Delegated Report

Approval of Details Application

Application no: 20231293

Location: 62 Windmill Street Gravesend Kent

The details submitted in this approval of details application in drawing no. 23-1433-13 – Entrance door details are as follows:

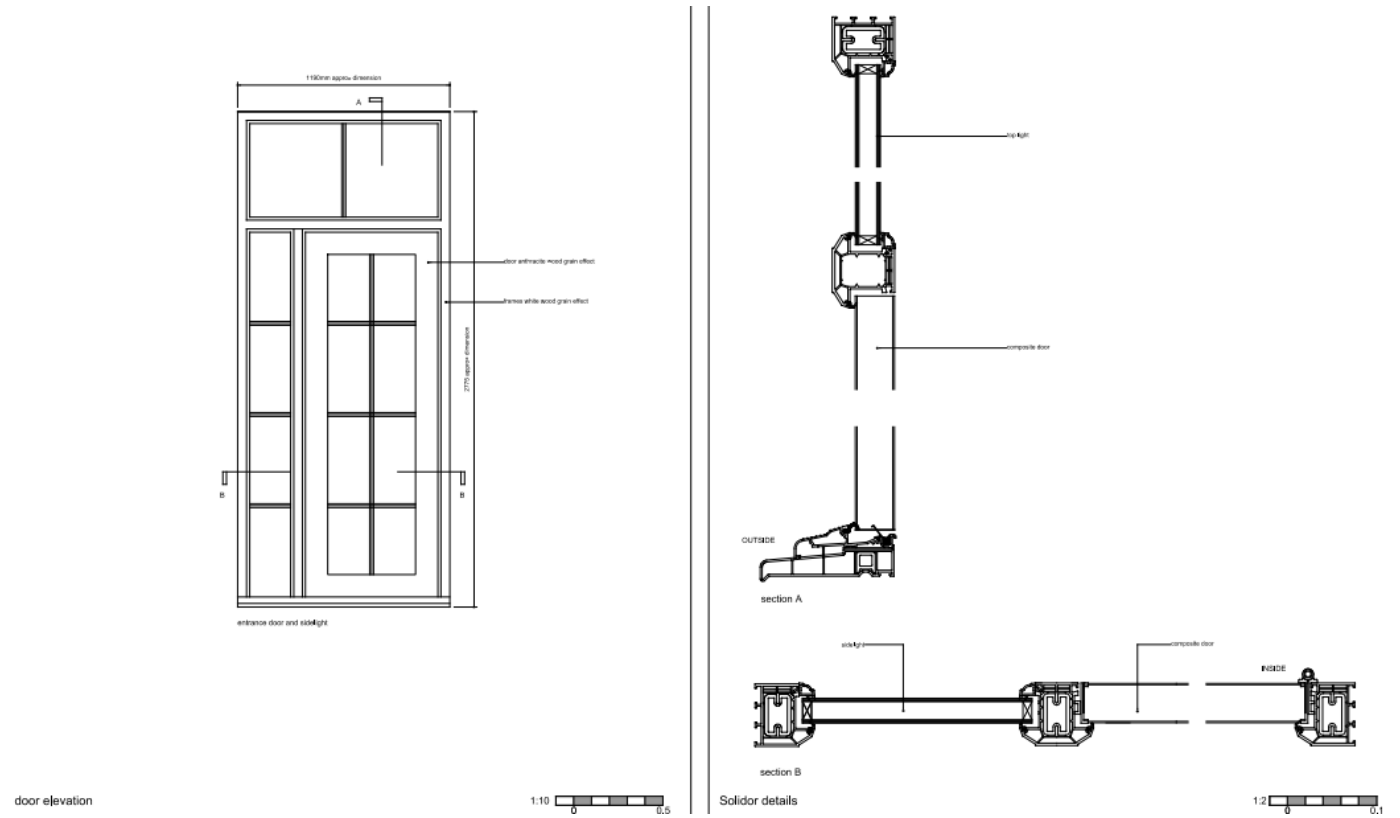
The submitted details show that the proposed material for the door would be composite in a wood grain effect and the colour of the door would be anthracite; the frame would be white wood grain effect. The 1:2 details show that the proposed door and frame would be of extremely thick and chunky proportions with a thick double glazing system for the side light also. Given the existing window which is to be replaced and the rest of the windows and door in the north elevation are in timber, it would be expected that the new door would be timber, not composite. Timber is the authentic material for a door in this age and style of building, not composite, and in timber the proportions of the door would be much more sympathetic and elegant rather than the thick and chunky proportions of the composite door which is proposed. The colour of the door in anthracite is also considered unacceptable as the existing window which is to be replaced and the rest of the windows in the north elevation are white therefore, anthracite would appear out of keeping particularly combined with the unacceptable composite material proposed. The door further back in this elevation is green but this door is in a different context as it is towards the back of this elevation and not part of the front section with the windows in their deep architraves, where one of these windows is to be replaced with a door. Where the new door would replace an existing window, the context of those windows in their deep architraves is white in terms of colour, as such anthracite would appear out of keeping.

Overall, therefore the submitted details show that the proposed door by virtue of its composite material, thick and chunky proportions, thick double glazing for the side light and its colour would be an unsympathetic addition which would be out of keeping with the character and appearance of the host building and would not preserve the character or appearance of the Upper Windmill Street Conservation Area but would cause harm to it. As such the proposal is contrary to Policies CS19 and CS20 (LPCS) and saved Policy TC3 (LPFR).
